MHP NEBEL STREET SITE PLAN AMENDMENT NO. 82022015A

This Application seeks to amend previously approved conditions to relocate overhead utilities across the street instead of underground along the Site's Nebel Street frontage, reduce the total vehicular parking count by three (3) spaces and revise the public benefits points table and architectural sheets to correspond to proposed parking changes.

Site Plan No. 82022015A Completed: 6-29-2023 MCPB Item No. 7-13-2023 Montgomery County Planning Board 2425 Reedie Drive, Floor 14 Wheaton, MD 20902

Figure 6: Proposed Overhead Utility Option No. 2, north of Nebel Street at Georgetown Road

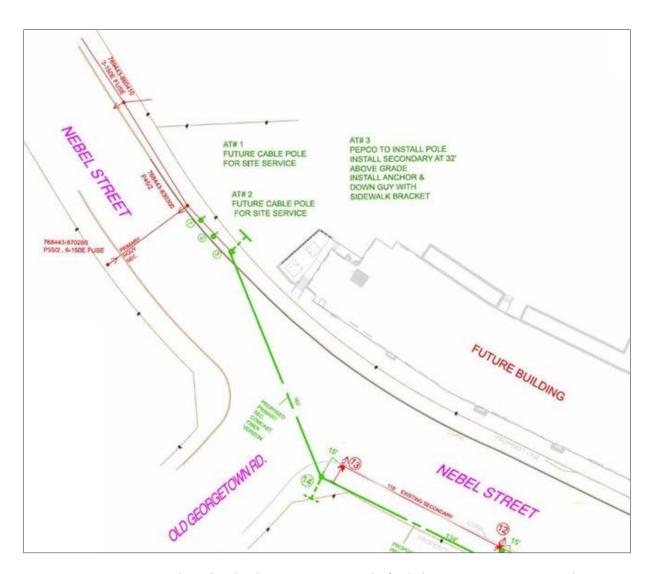
The proposed Site Plan Amendment would result in an improved Property frontage when considering the total number of utility poles to remain when compared in two new overhead utility relocation scenarios (Attachment C). Proposed Overhead Option No. 2 has two (2) fewer poles than the undergrounding scenario that was submitted with the initial Site Plan. According to the Applicant's utility consultant, the following utility work is required to implement the proposed Overhead Utilities Option No. 2:

- Install two (2) new poles north of the MHP building and relocate one (1) existing pole north of the MHP building.
- Install no new poles south of the MHP building and no guy/support poles in front of the MHP building.
- Replace three (3) existing poles on the opposite side (south side) of Nebel Street. These poles will be slightly shifted away from the curb to the edge of the right-of-way.
- Install overhead wires on the poles on the opposite side (south side) of Nebel Street and remove the overhead wires from in front of the MHP building.

- ii. The Applicant must re-route existing overhead facilities on the north side of Nebel Street to existing pole infrastructure located on the south side of Nebel Street and move the poles away from the curb to the edge of the right-of-way within the sidewalk buffer to maintain the minimum sidewalk clearance, open space, and landscape planting plan.

Figure 9: Proposed Changes to the Approved Nebel Street Cross-Section

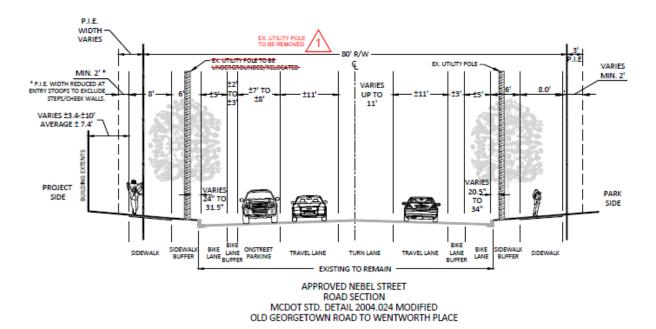
Additionally, because of the proposed utility relocation across the street, the previously approved Nebel Street road cross-section will be modified to not eliminate the existing poles as annotated in Figure 9.

- a) Include the stormwater management concept approval letter, development program, and <u>amended</u> Site Plan resolution (and other applicable resolutions <u>and agency letters</u>) on the approval or cover sheet(s).
- d) Modify data table to:
 - i. Reflect development standards approved by the Planning Board and <u>the revised</u> <u>vehicular parking count.</u>
 - ii. Clarify dedications as previous or proposed.
- t) <u>Include the revised overhead utility relocation exhibit in the plan set with overlapping boundaries for the southern open space and tree planting details and revise the Nebel Street road cross-section to reflect the revised utility pole reconfiguration.</u>
